**MINUTES OF A REGULAR MEETING OF THE CASA GRANDE
PLANNING AND ZONING COMMISSION HELD ON THURSDAY,
FEBRUARY 6, 2014 AT 6:00 P.M. IN THE COUNCIL CHAMBERS AT
CITY HALL, 510 E. FLORENCE BOULEVARD, CASA GRANDE,
ARIZONA.**

DSA-13-00158: Major Site Plan to construct a 21,030 Sq. Ft. manufacturing/warehouse building addition and a new parking lot on the Hexcel Corporation Manufacturing 4.24 acre site located at 1214 W Gila Bend Hwy.

**Planning and Zoning
Commission
STAFF REPORT**

1. DSA-13-00158: Major Site Plan to construct a 21,030 Sq. Ft. manufacturing/warehouse building addition and a new parking lot on the Hexcel Corporation Manufacturing 4.24 acre site located at 1214 W Gila Bend Hwy.

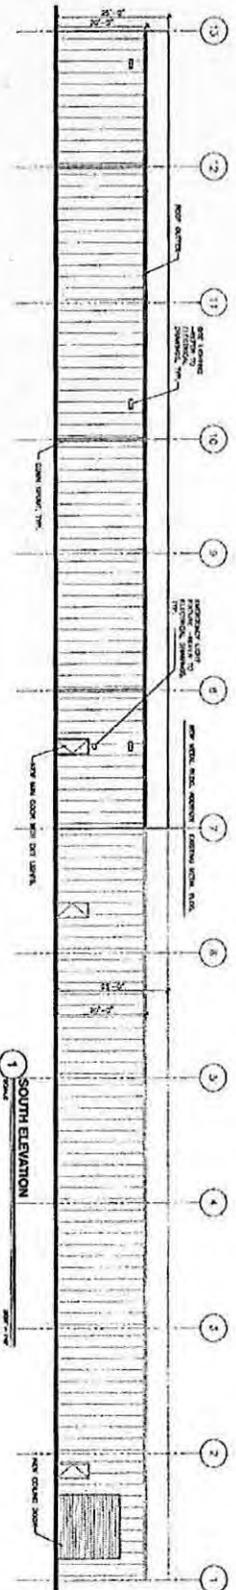
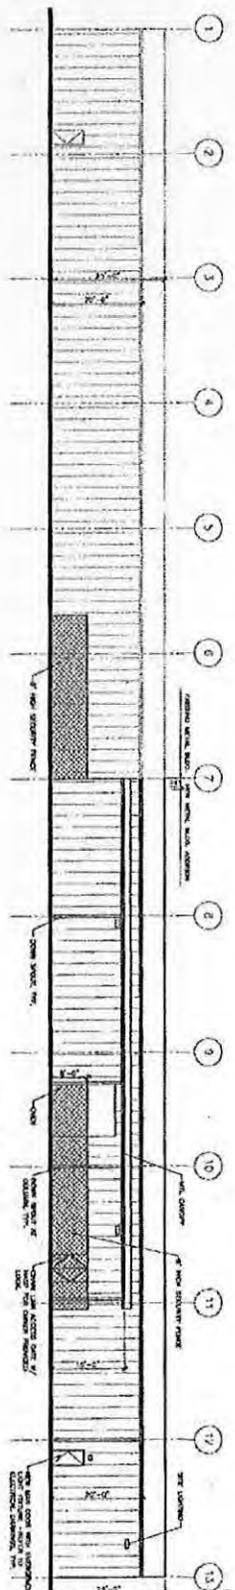
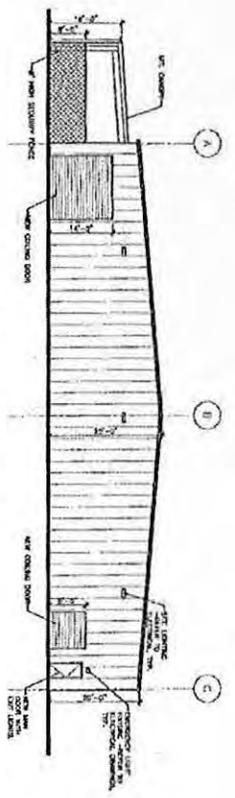
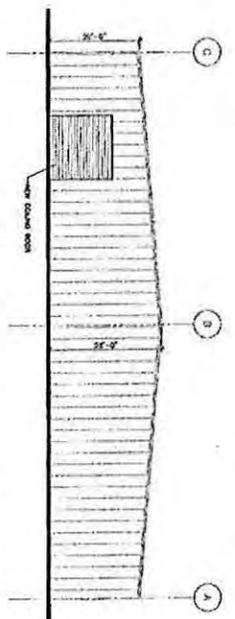
1. Revise the location of all attached lighting on the proposed addition to match the locations as shown on the site plan and lighting photometric plan.

CONCEPTUAL GRADING AND DRAINAGE PLAN FOR HEXCEL CORPORATION PARKING LOT NORTH VIP BOULEVARD CASA GRANDE, ARIZONA

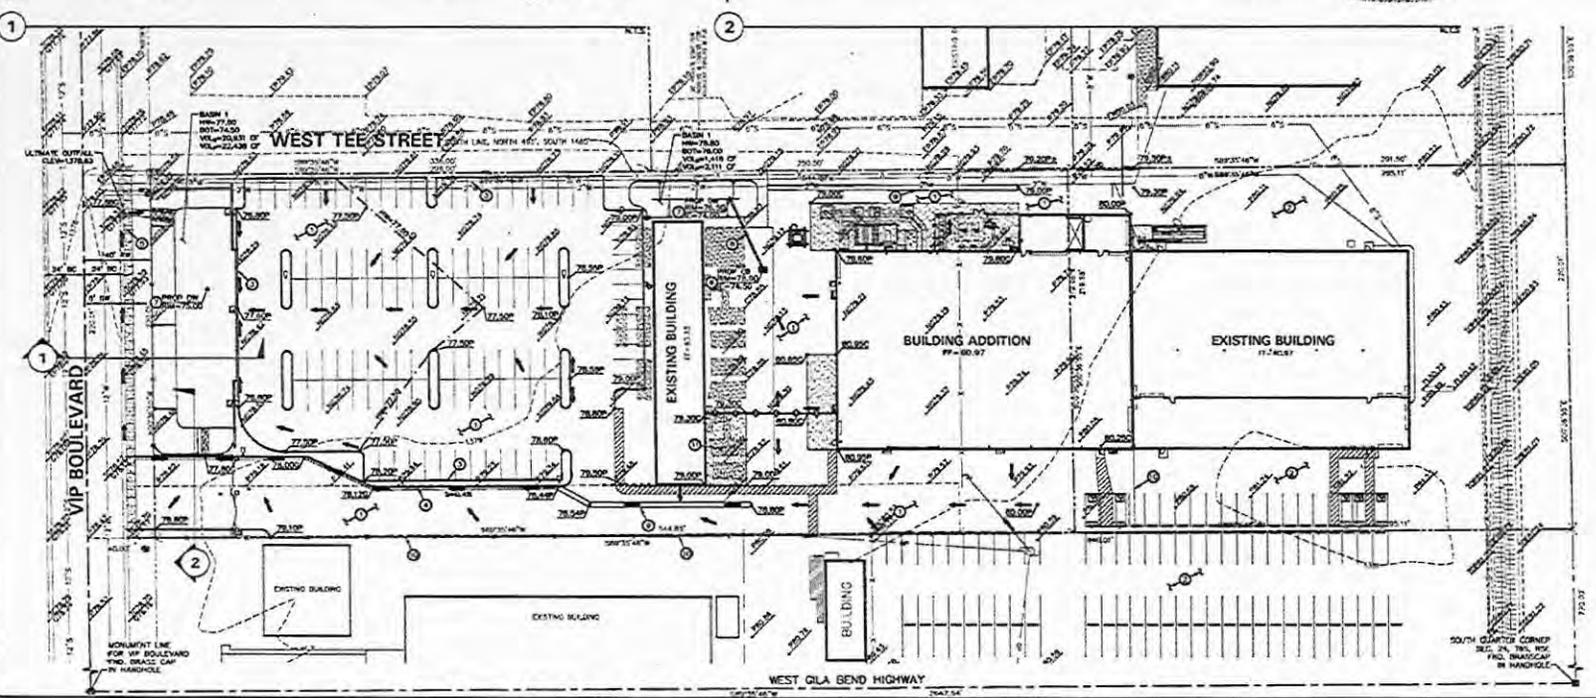
- a. Provide the details of call outs shown on the conceptual grading and drainage plan.
- b. Provide a grading and drainage plan for the existing building and building addition (15.40.520) along with hydrological and hydraulic calculations.

- c. Provide hydrological peak flows calculations used for the proposed curb openings sizing.
- d. Revise the drainage design and provide hydrologic and hydraulic calculations to include all water which falls within the respective one-half of all abutting streets (Including W Tee Street) to the development from a 100-year storm event of a 1-hour duration as it must be retained within the boundaries of the development (15.40.1240A, 15.40.1250A, 702.1).

- e. Size the site retention basins for the developed stormwater flows generated from the whole site (15.40.520) with runoff coefficients established in the City code 15.40.1290 to meet the code requirements. Weighted runoff coefficient may be estimated and can be used for calculations. Retention basin for area BA2 shall also be provided.

- f. Revise the run off coefficients for pavement area per City Code Section 15.40.1290. The run off coefficient of 0.9 proposed is inconsistent with the City code required 0.95 for pavement area. Weighted runoff coefficient may be calculated and used for calculations.

- g. Clarify the retention volume over the "PARKING LOT". Also show the limits of retained storm water with maximum water depths.
- h. Provide a Retention Basin Drainage Easement along VIP Blvd.: Retention basins shall be protected from further development by a recorded drainage easement (15.40.1240.D, 702.1.4)

- i. Provide retention basin bleed off calculations. All the retention basins must drain within 36-hours with and/or without drywells. A shallow pit

percolation tests shall be performed in retention areas to determine natural percolation. Test results shall be submitted to the city engineer prior to approval of drainage plans (15.40.1290.C).

- n. Perform shallow pit percolation tests in retention areas to determine natural percolation. Please provide the bleed off calculations of the retention basin in conformance with the standard for disposal of the total ponding volume within 36 hours. Please indicate if the drywell is required. (Ch 15.40.1290).

- o. Provide hydraulic (weir) calculations from retention basin (1) by allowing it to spill out to the storm water outfall (over topping West Tee Street). Please indicate if the outfall will be maintained in post development condition. A drainage easement maybe required to provide proper passage of this flow across W. Tee Street.

- p. Show the elevation of the ultimate outfall.
- q. Show pavement (thickness) cross section of the parking lot.
- r. Label the proposed concrete curb/gutter & sidewalk into MAG Std Detail #

- e. The size of the site retention basins for the developed storm water flows generated from the whole site with runoff coefficients established in the City Code 15.40.1290 are subject to compliance with Section 15.40.1280.I to the resolution and satisfaction of the City Engineer. Weighted runoff coefficient may be estimated and can be used for calculations. Retention basin for area BA2 shall also be subject to the resolution and satisfaction of the City Engineer.
